**PLANNED UNIT DEVELOPMENT &
PLANNING APPROVAL STAFF REPORT****Date: March 9, 2017****DEVELOPMENT NAME**

St. Luke's Episcopal Upper School

Planned Unit Development approval to amend a previously approved Planned Unit Development to allow multiple buildings on a single building site and Planning Approval to amend a previously approved Planning Approval to allow new lighting for the athletic area, new stationary and moveable bleachers, and a press box at an existing school in a B-1, Buffer Business District.

SITE PLAN

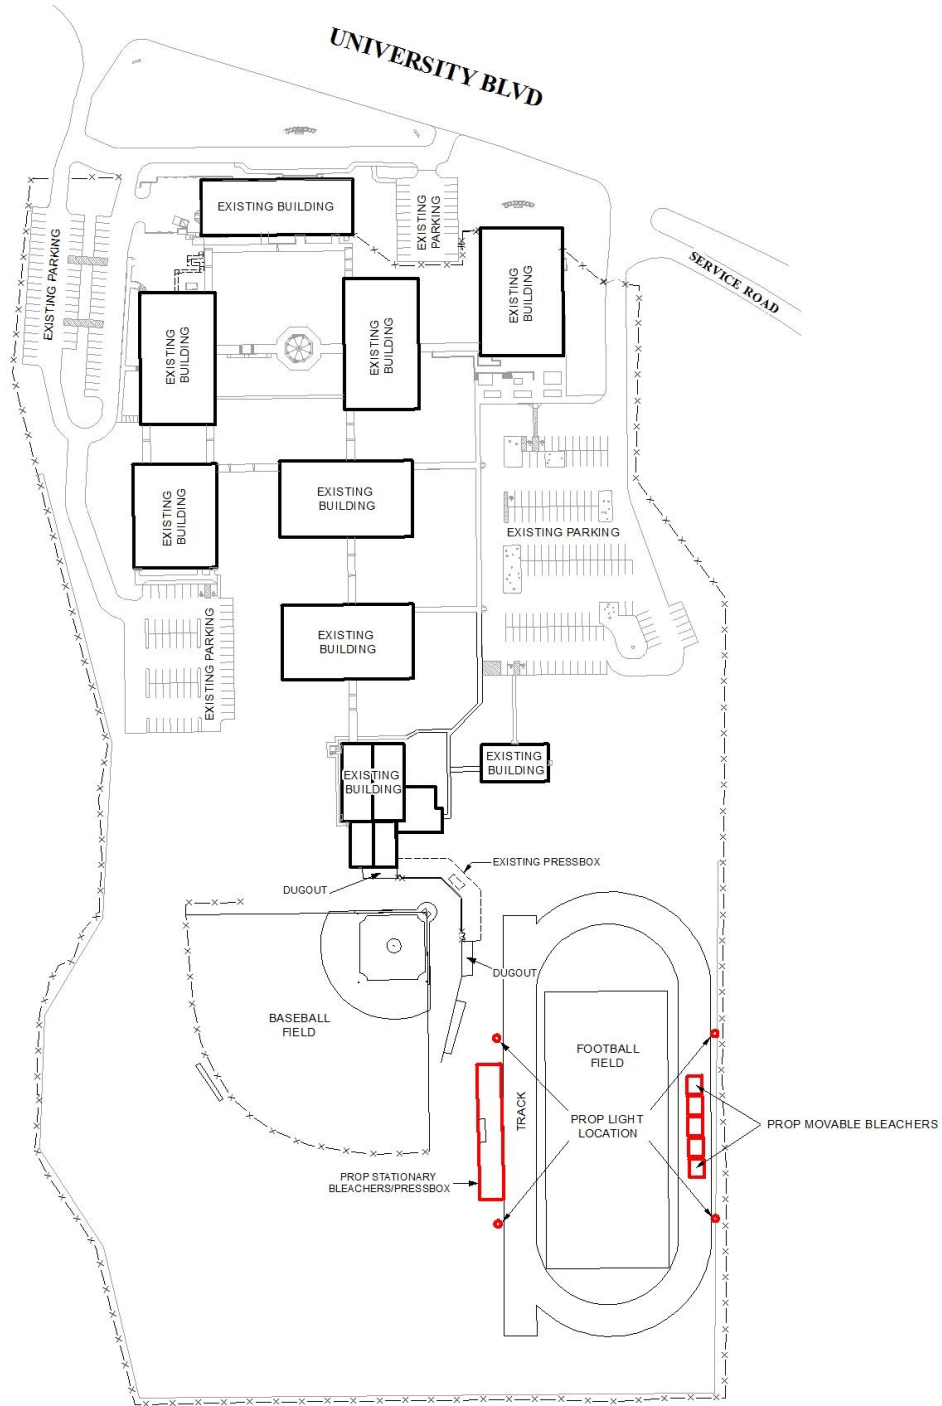
The site plan depicts the four newly proposed light poles located along all four corners of the football/ soccer field. The applicant states that the field will be utilized August through November between two and four nights per week for a five to eight week period, and from February to April two to four nights per week for seven weeks. The hours for both seasons have been determined to be from 5:00 pm to 9:30 pm. Based on the fact the football/ soccer field will be illuminated and used for after-hour activities a 20-foot vegetative buffer in compliance with Section 64-4.E. of the Zoning Ordinance will be required along perimeter of the property where

the field abuts the residential property. After reviewing the photometric plan, it appears that the lighting exceeds the required 0.2 foot candle limit where the site abuts residential property along the eastern boundary of the site. A revised photometric plan in compliance with Sections 64-4.A.2 and 64-6.A.8 of the Zoning Ordinance will be required, thus the applications should be heldover.

1. submission of a revised photometric plan in compliance with Sections 64-4.A.2 and 64-6.A.8 of the Zoning Ordinance, showing foot candle levels not exceeding 0.2 foot candles at the Eastern property line; and
2. verification regarding if a public address system is proposed.
